Subject: Comments and Information Request

The Wisconsin Department of Natural Resources (DNR) appreciates the opportunity to review updated erosion and sediment control maps and plans, HDD profiles, geotechnical information, and hydrofracture analysis for the Enbridge Energy Line 5 Wisconsin Segment Relocation Project, as part of the Notice of Intent to request coverage under the Construction Site Storm Water Runoff General Permit No. WI-S067831-6.

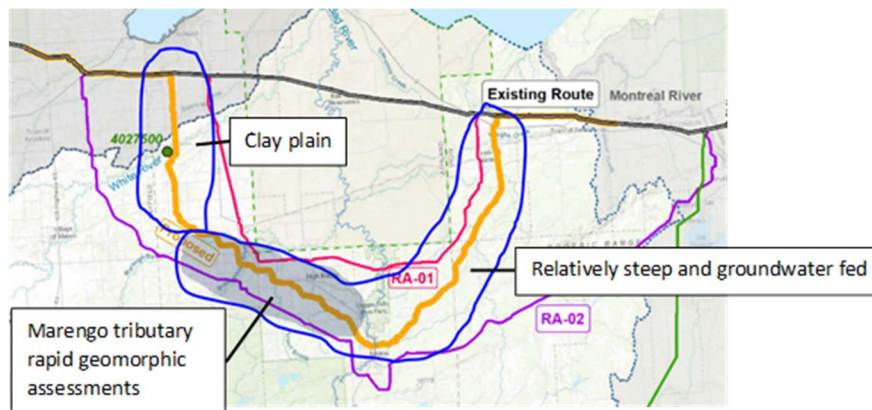
- l. Artesian conditions encountered or indicated by Geotech bores, nearby well logs, or other information sources
- m. Regional differences in geomorphology, erosion hazard, and groundwater contribution between (1) the Clay Plain, (2) Clay-to-Sand/Gravel Transition Zone (i.e., Upper Marengo watershed), and (3) Penokee Hills/Copper Falls Formation (i.e., area east/northeast of the proposed Bad River crossing). (See map below.)
